Re: Wrentham Business Park, 10 Commerce Boulevard Response to Abutter Comments

RE: Response to Comments 10 Commerce Boulevard, Wrentham, MA

RE: 10 Commerce Boulevard

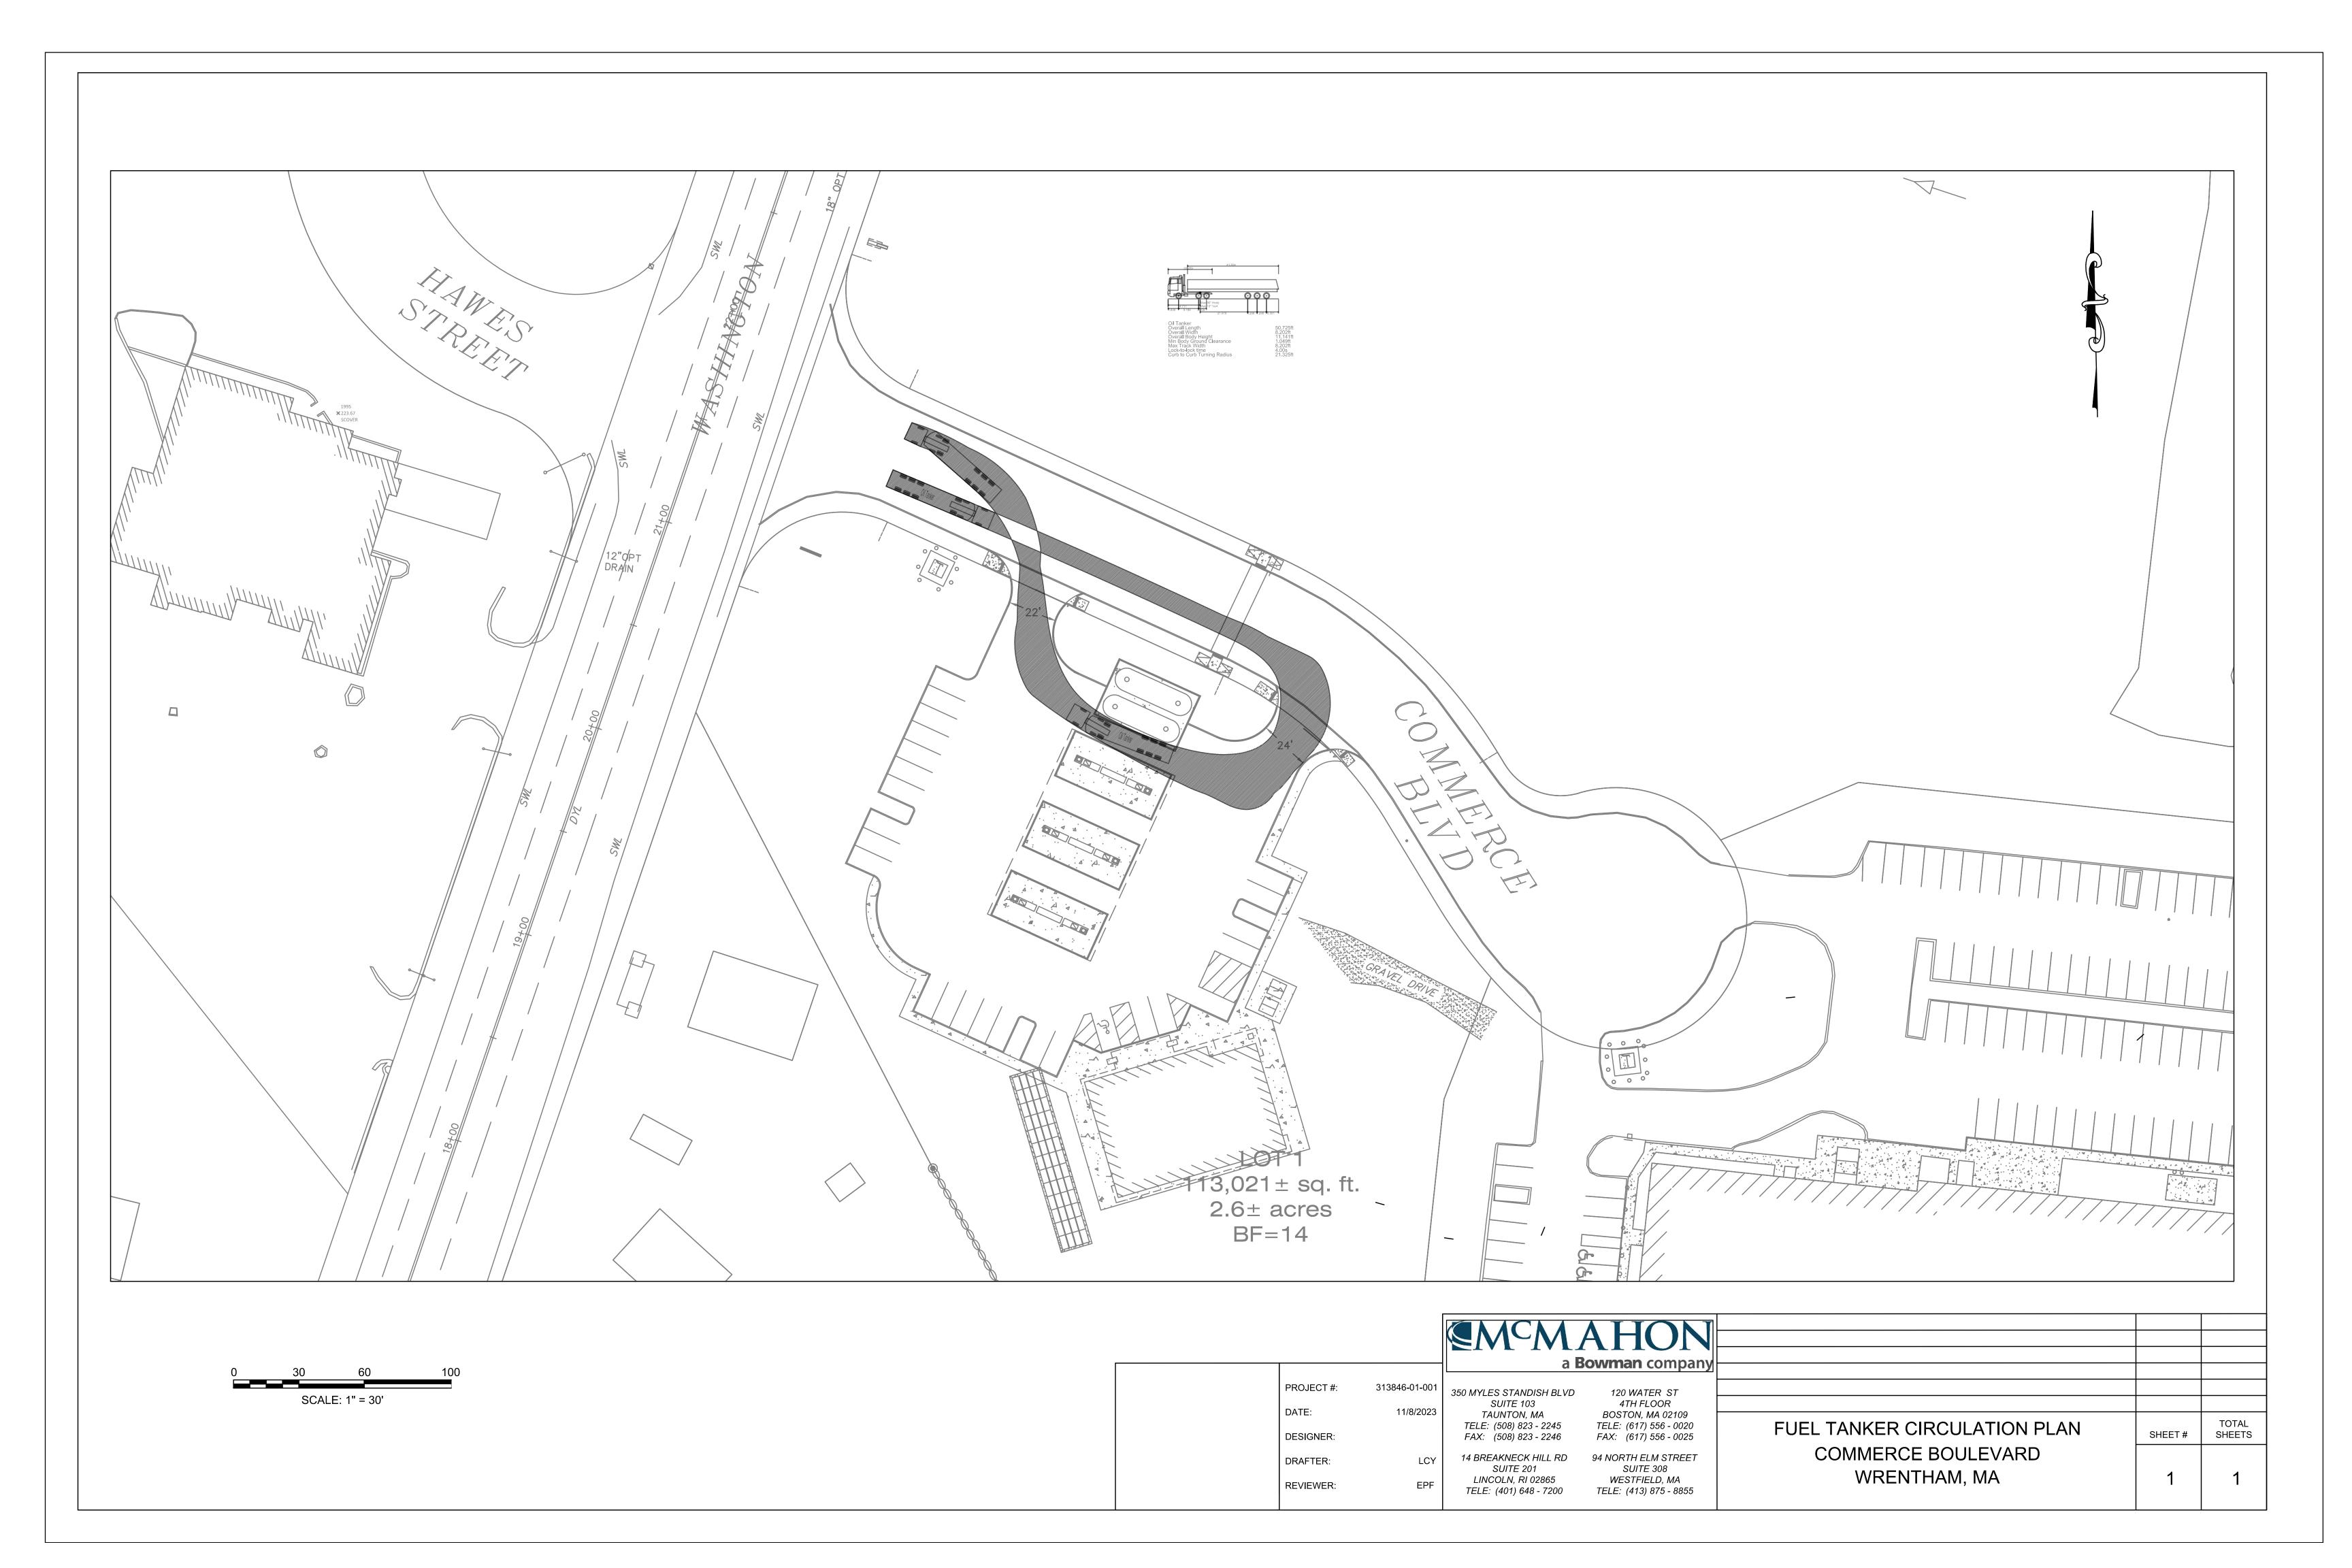
Comment 1: It is recommended that revised truck turning plans be provided to demonstrate that exiting trucks are able to reverse direction back to Route 1, without creating potential conflicts with opposing traffic flow on Commerce Boulevard. Lastly, it is recommended that the turning template plans clearly identify where the fuel truck will be parked when unloading fuel, and whether multi-point maneuvers on site are required for the truck to navigate into this unloading area.

Response 1: A revised truck turning plan has been completed demonstrating the exiting truck towards Route 1. The turning plan also depicts the location of the stopped fuel tanker adjacent to the underground storage tanks and outside of the fueling positions for the gas station customers. Multi-point maneuvers are not expected to be necessary for trucks to navigate the project site. The truck turning plan is attached to this response to comments.
